Agenda
City of Springboro Planning Commission Meeting
Wednesday, September 8, 2021, 6:00 p.m.
Council Chambers, Springboro City Building, 320 West Central Avenue

Background Information & Staff Comments
City of Springboro Planning Commission Meeting
Wednesday, September 8, 2021, 6:00 p.m.

Site Plan Review, 95 West Central Avenue (SR 73), proposed vehicle service facility for Foreign Exchange

C-3.0

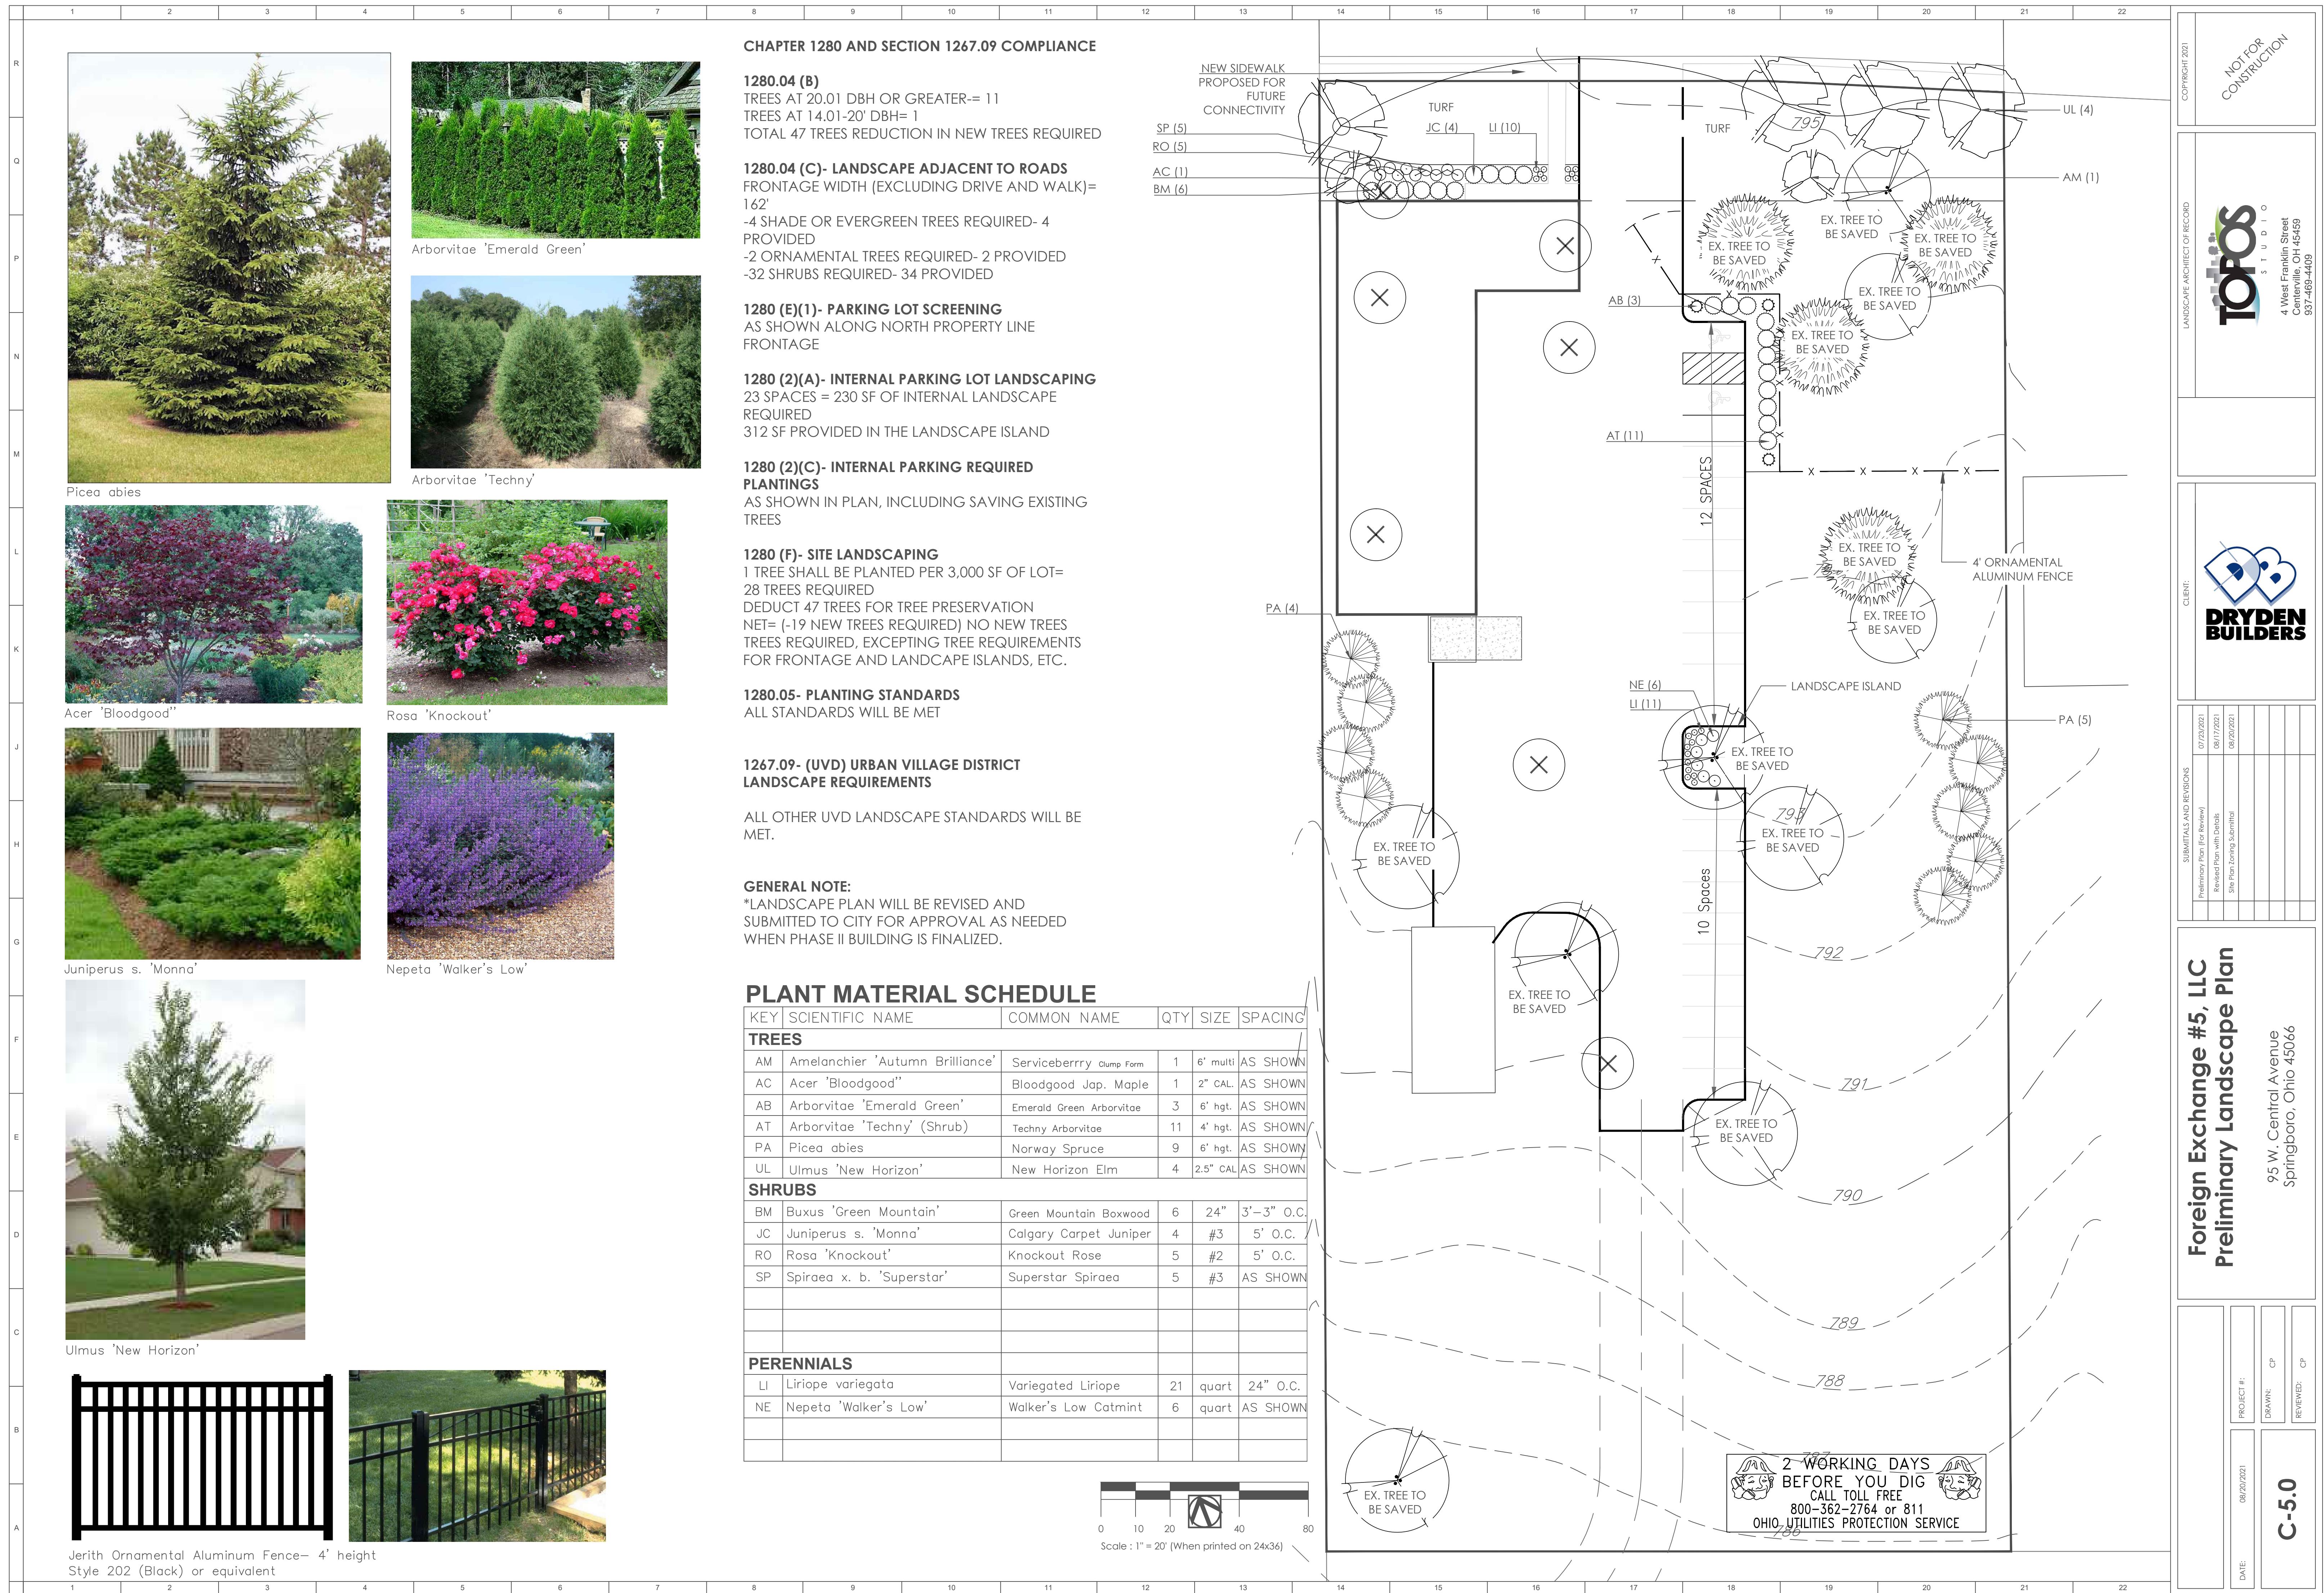
11. Provide side yard swale slope information into basin with spot elevations.
12. Label storm structures on plan view.
13. Provide a 5 foot wide sidewalk along the frontage, including through the 7" concrete driveway apron, with a 2 foot tree lawn.

20. Provide proposed contours in parking/drive aisle and spot elevations throughout.
21. Clearly show the limits of the curbing for the parking lot and drive aisle.

24. Verify the location of the building on C-2.0 Layout Plan on the 70 foot dimensional arrow.
25. Final revised and approved site plan shall be submitted to include all comments by staff and planning commission to have signature of the owner or duly authorized officer and stamped certified by a professional engineer.

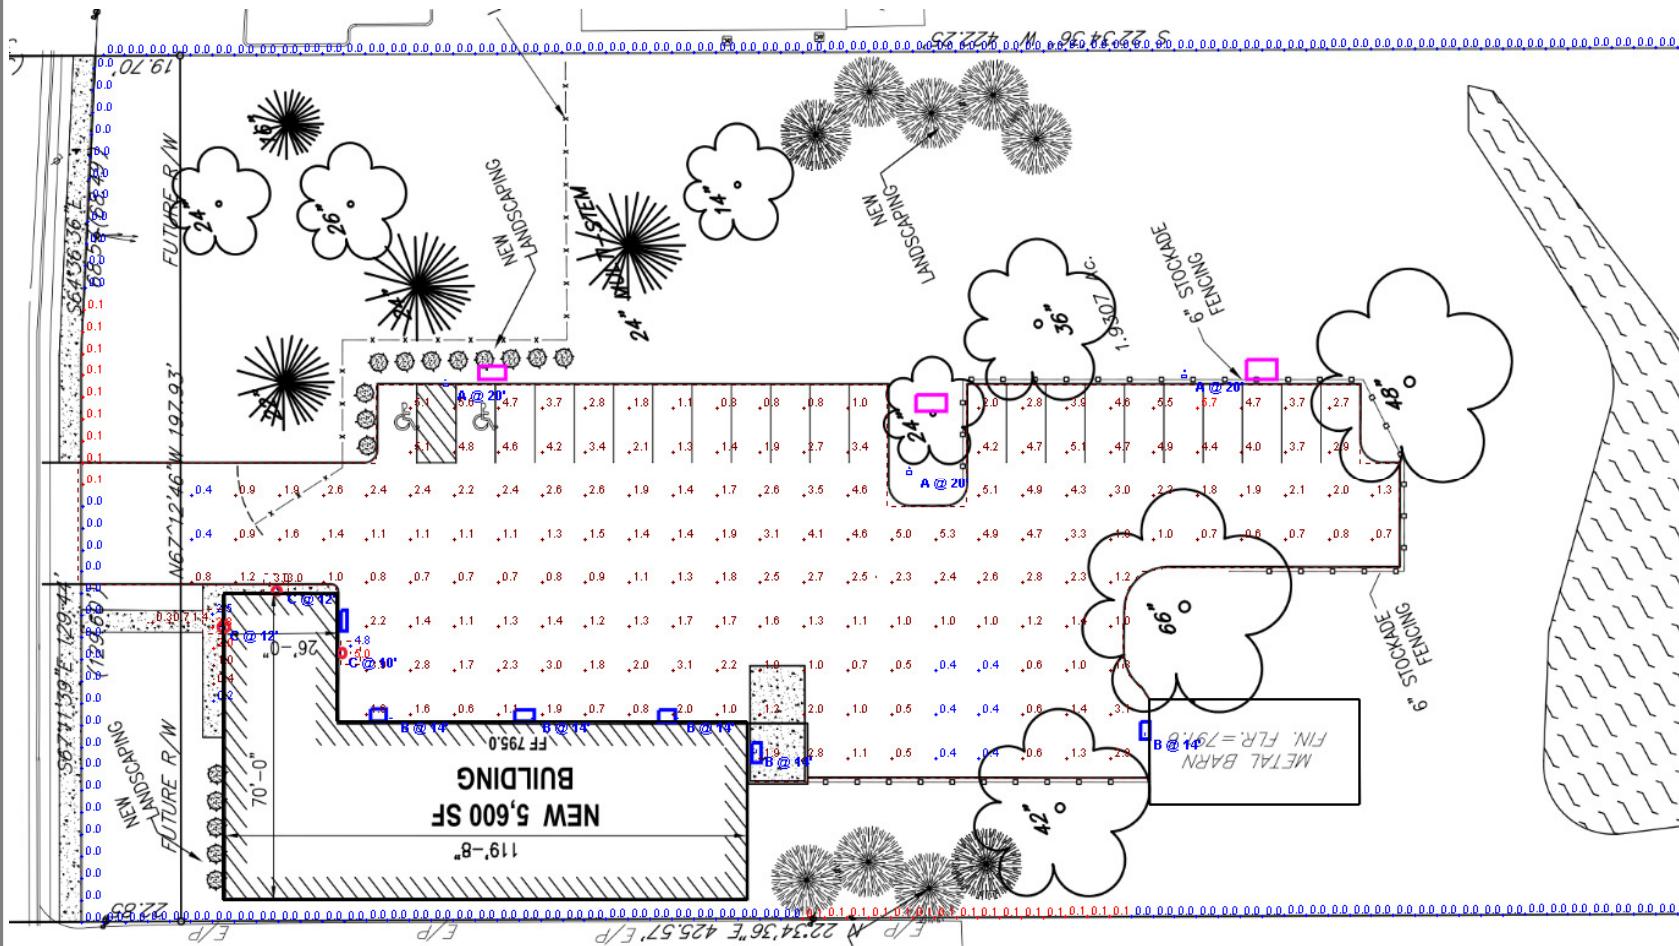
2. For proposed lighting plan, address the following:
 - (a) Include ratios for maximum to minimum and average to minimum.
 - (b) Verify that proposed light fixtures are 3500° degrees Kelvin or less. Fixtures A and B appear to not comply.
 - (c) Verify that proposed fixture C complies with flush-mounting provides of code.
3. Indicate plans (timetable, setbacks, size and other details) for implementing future building areas shown on sheet CP-2.0. If not concurrent with proposed building/site proposed under this application, remove and revise site plan to comply with screening and landscaping and other provisions including the vehicle storage portion of the pavement. If the proposed building are to be developed at this time, building plans and design/development information is needed at this time that comply with UVD/Planning & Zoning Code standards.
